**POLK COUNTY, A POLITICAL SUBDIVISION OF THE STATE OF FLORIDA
ADDENDUM # 7
BID # 26-112, COUNTY ROAD 557 WIDENING
FPID Project No. 445143-2-54-01**

ADDENDUM # 7

BID # 26-112, COUNTY ROAD 557 WIDENING

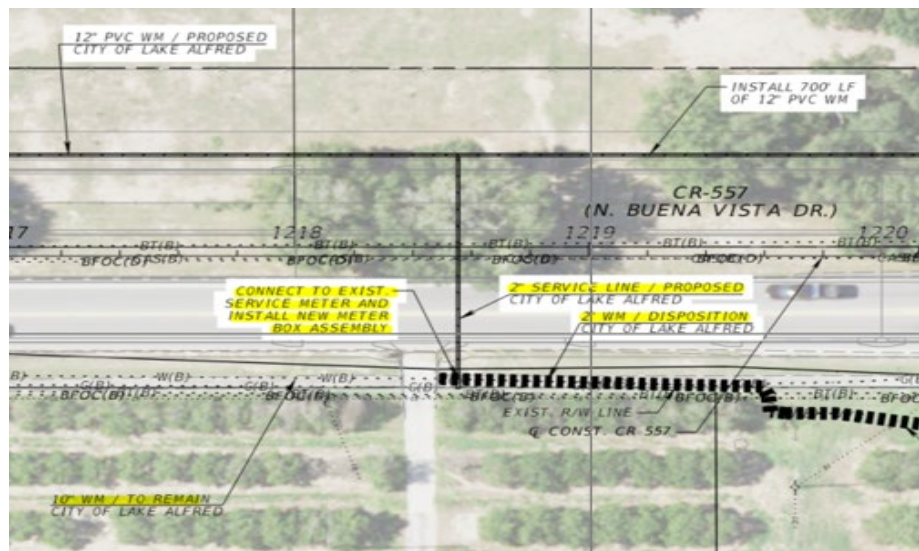
- A11: Asphalt and base removal are included with clearing and grubbing and there is no adjustment to the earthwork volumes.
- Q12: There is discrepancies between the quantity shown in the Bid Sheet and the Roadway Plans Cross Section for Pay Item 120-74: Surcharge Embankment. When adding up the volume quantities in the Roadway Cross Sections for Surcharge Embankment you get to 5,584 CY. Bid Sheet has 4,923 CY for Surcharge. Please confirm quantity for Pay Item 120-25D: Surcharge Embankment and provide Bid Sheet with quantities that match Quantities shown in the Plans.

A12: The Bid sheet quantity is correct.
